Intel[®] 840 Chipset: 82840 Memory Controller Hub (MCH)

Specification Update

January 2001

Document Number: 290697-001

9. 82840 MCH Processor Lock Read to AGP

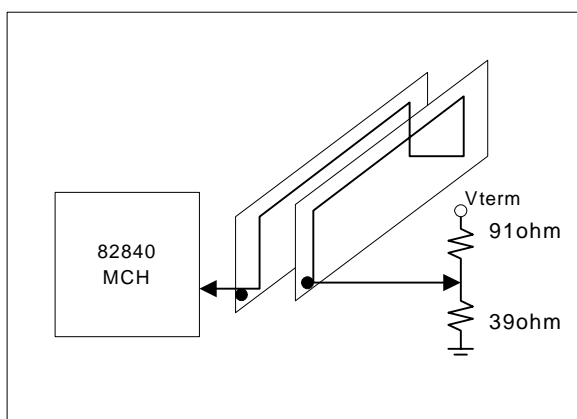
Problem: An AGP deadlock will occur during a locked processor-to-AGP read cycle under the following sequence:

- Heavy processor-to-AGP traffic must exist.
- An AGP device launches an AGP high-priority read to two or more cache lines.
- A snoopable read or write access to system memory is received (e.g., PCI FRAME transaction), which propagates up from AGP, hub interface A or hub interface B. This cycle must access, or prefetch into, one of the cache lines being requested by the AGP high priority read generated in sequence #2, above.
- The processor issues a locked read toward AGP.

Implication: The OS/driver must allow sequence 2 and 3 to access the same page. This combination conditions and sequence will cause the system to hang.

Workaround: None identified

Status: This erratum was fixed in the B2 stepping.
